| Project | IEEE 802.16 Broadband Wireless Access Working Group < http://ieee802.org/16 > | |
| Title | Uncoordinated Coexistence Protocol (UCP) | |
| Re: | Working Group Review of Working Document IEEE 802.16h-06/015r1 | |

Figure x: EQPs Map Relevance = n+1

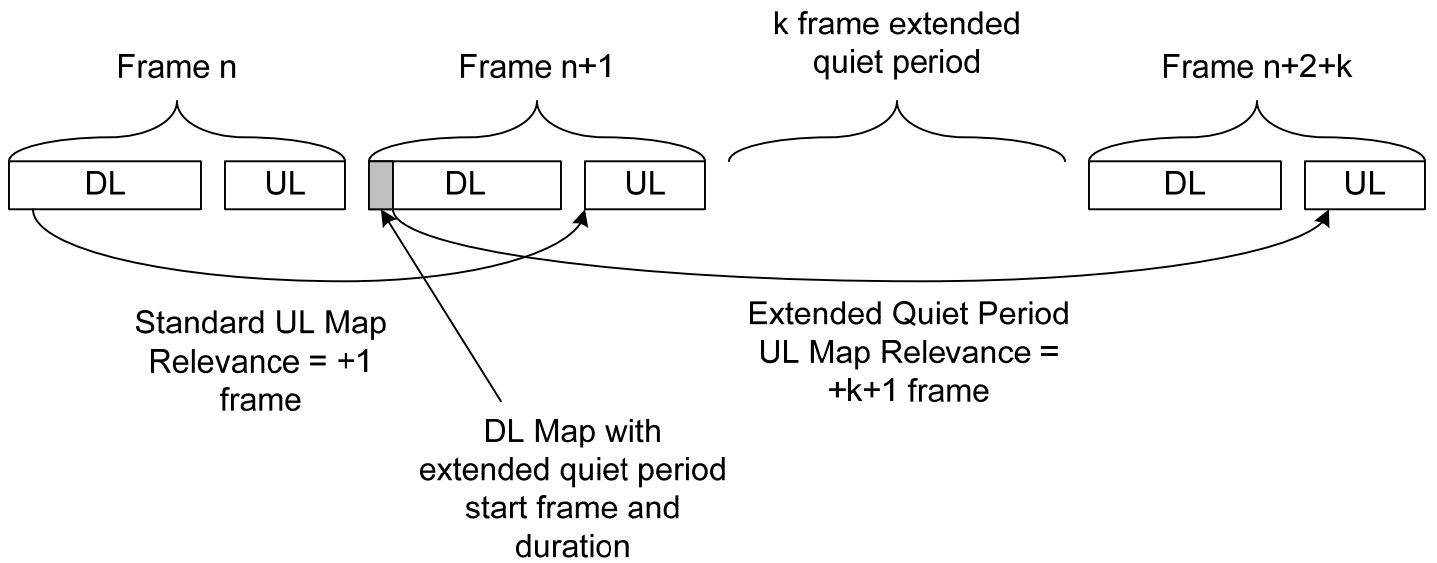
The duration, in frames, of the EQP is signaled in the DL-MAP using the EQP_IE defined in 8.4.5.3.29. The EQP always starts in the frame following the DL-MAP containing the EQP_IE. In addition to the duration of the EQP, the report_requested field indicates whether measurement and reporting on the channel should be performed during the EQP. If the report_requested bit is set to 0, no automatic measurement and reporting is requested. When it is set to '1', then all SS will make measurements as if commanded to create a *Basic Report* in REP-REQ (11.11). They will transmit a corresponding REP-RSP message if a measurement detected activity above the threshold for the frequency band of operation. The need for bandwidth to transmit a report may be signaled through any of the standard methods for signaling a need for UL bandwidth. When the UL-MAP relevance is the next frame as it is for WirelessMAN-OFDMA based systems, the UL-MAP transmitted in the last DL subframe before an EQP describes the allocations for the first UL subframe after the EQP. This is shown in Figure x. The periodicity of EQP is described in the next sub clause. This discontinuity of the UL-MAP relevance does not exist in the case where the UL-MAP describes the allocations for the current UL subframe as is possible in some WirelessMAN modes. In this case the DL and UL subframes can be more closely associated with each other. This will be important for a listen-before-talk capability. The case of EQPs with UL-MAP relevance for the current frame is shown in Figure x2.

Figure x3: Adaptive EQP (with example parameter numbers)

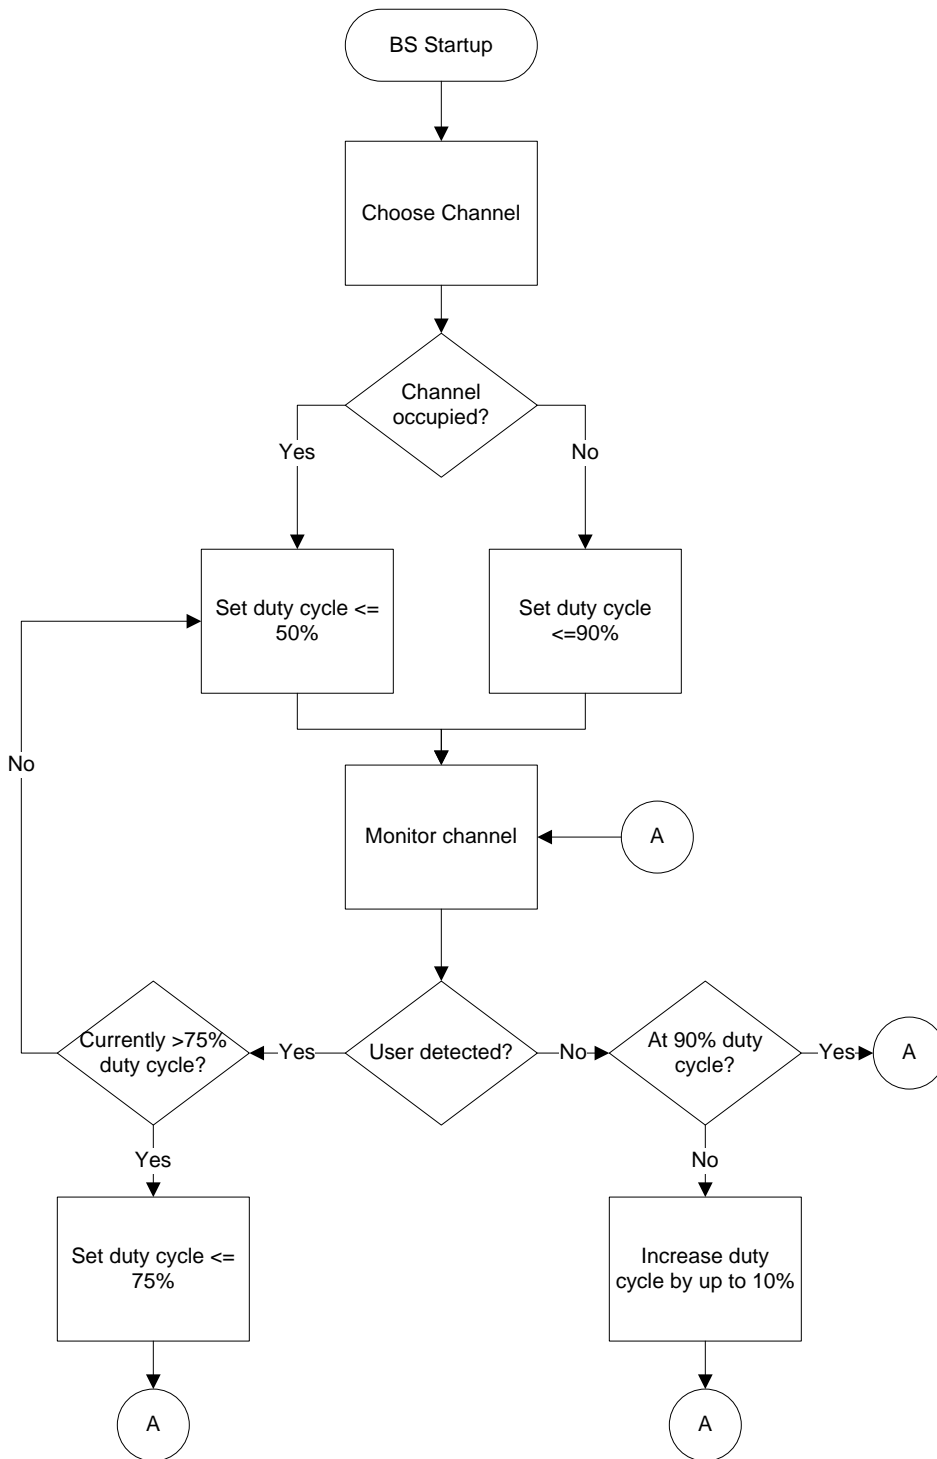
There may be bands where there is a possibility of other users, but the probability is low. In these cases, it is important to not waste bandwidth catering to non-existent users of the band. When EQPs are used in a non-exclusively assigned or licensed band, a BS initially offering service shall perform an initial (DFS/DCS) scan and pick the *best* channel. Based on this choice, if the channel is thought to be free of other users, the BS shall set the initial duty cycle to no more than *max_duty_cycle*. If another user was detected, the BS shall initially operate a duty cycle of no more than *share_duty_cycle*. Duty cycles are measured over a 1 second period. This duty cycle can be achieved a number of ways. For instance a 50% duty cycle can be achieved: with the use of every other frame, *n* frames on and *n* frames off, or operate in *n/2* of *n* frames, etc. The method of achieving the duty cycle shall be left for vender differentiation which increases the likelihood of randomization of the algorithm of two different BS from two different operators which in turn increases the likelihood of their ability to eventually detect each other or an SS associated with the other BS.

If after a prolonged period which is band specific in duration, the BS and its associated SSs have not detected other users in the band through measurement and reporting during EQPs coupled with measurement and reporting as performed for DFS/DCS then the BS may increase its duty cycle by *duty_cycle_step*. The duty cycle shall not increase above *max_duty_cycle* as measured over a 1 second period. The BS shall continue to measure and shall continue to instruct SSs to measure and report using the EQPs and the DFS/DCS mechanisms. If a SSU is detected, the band specific regulations shall be followed. If another user that is not a SSU is detected the BS shall reduce its duty cycle to at most *intermediate_duty_cycle* within 10 frames of the BS becoming aware of the detection. If the detected user persists, the BS shall reduce the duty cycle to at most *share_duty_cycle*. The flow is shown in Figure x3 using example parameters: *share_duty_cycle* = 50%, *intermediate_duty_cycle* = 75%, *max_duty_cycle* = 90%, and *duty_cycle_step* = 10%.

Figure x4: Listen-Before Talk

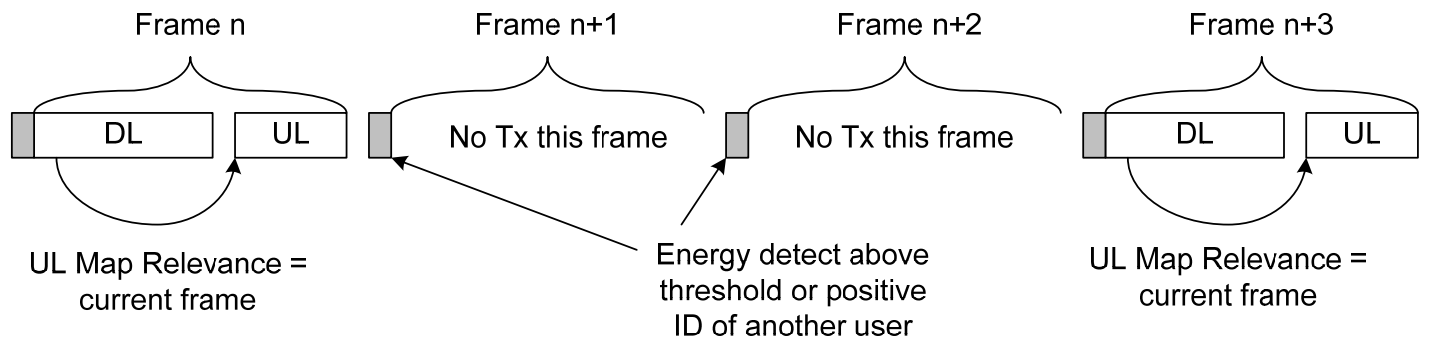
When attempting to coexist with certain non-802.16 users of non-exclusively assigned or licensed bands, EQPs may not be sufficient. In these cases, a listen-before-talk protocol must be used. In such bands, the BS shall operate with a UL-MAP relevance of the current frame. This allows the DL and UL subframes to be logically

viewed as a single “packet” of constant duration equal to the frame duration. The BS shall allocate the UL subframe such that a time period is reserved between the end of UL allocations and the start of the frame preamble for the next DL subframe as shown in Figure x4. This time period shall be used to sense other non-802.16 systems and shall have at least the durations specified in Table x2. Use of listen-before-talk shall not eliminate any requirements for other measurement and reporting that may be required for operation in a particular mode or band. Use of listen-before-talk shall not eliminate any requirement for use of EQPs.
